Ref: FCC Class II Permissive change for FCC ID: QDS-BRCM1019  
Applicant: Broadcom Corporation

Pursuant to Section 2.1043 of the FCC rules, we hereby request a Class II permissive change for FCC ID: QDS-BRCM1019, originally granted on 11/30/2005.

# BCM94311MCAG

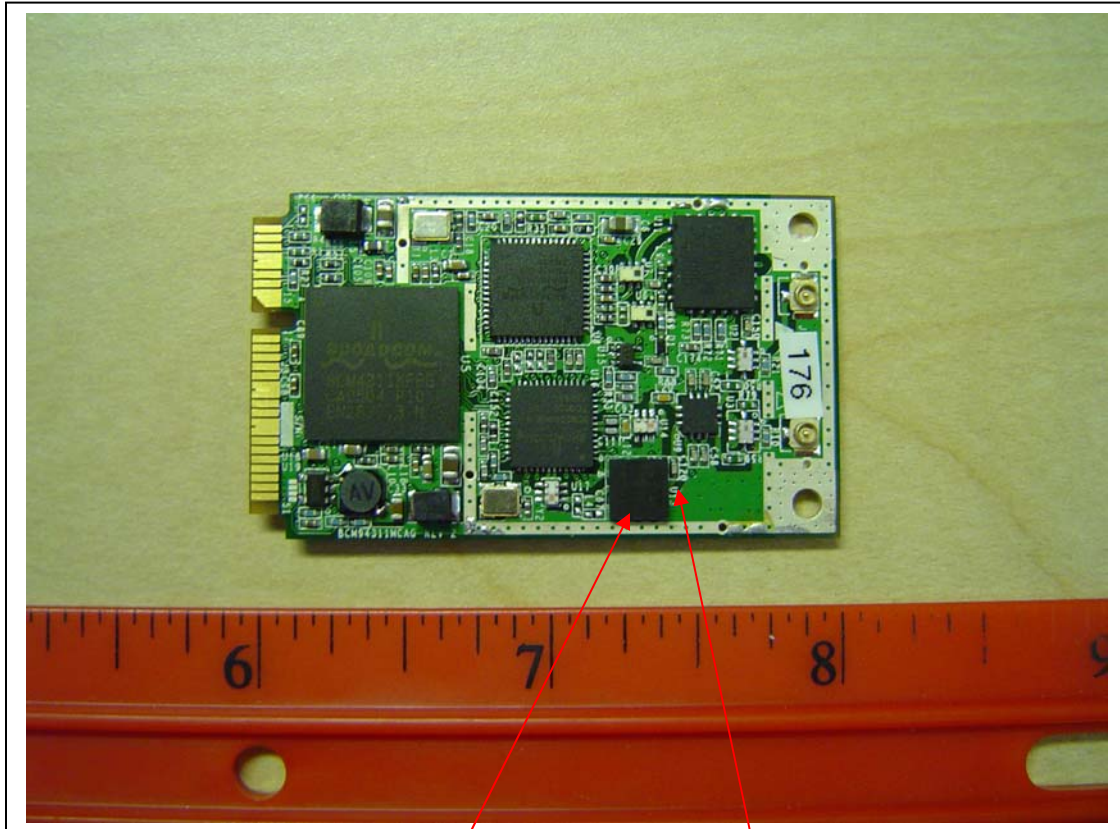
Change #1      The 5GHz power amp has been modified from a Fairchild to a Micromobio model and the associated layout and filter circuitry is slightly different. The output powers remain the same.

Alternate PA

A pad is added
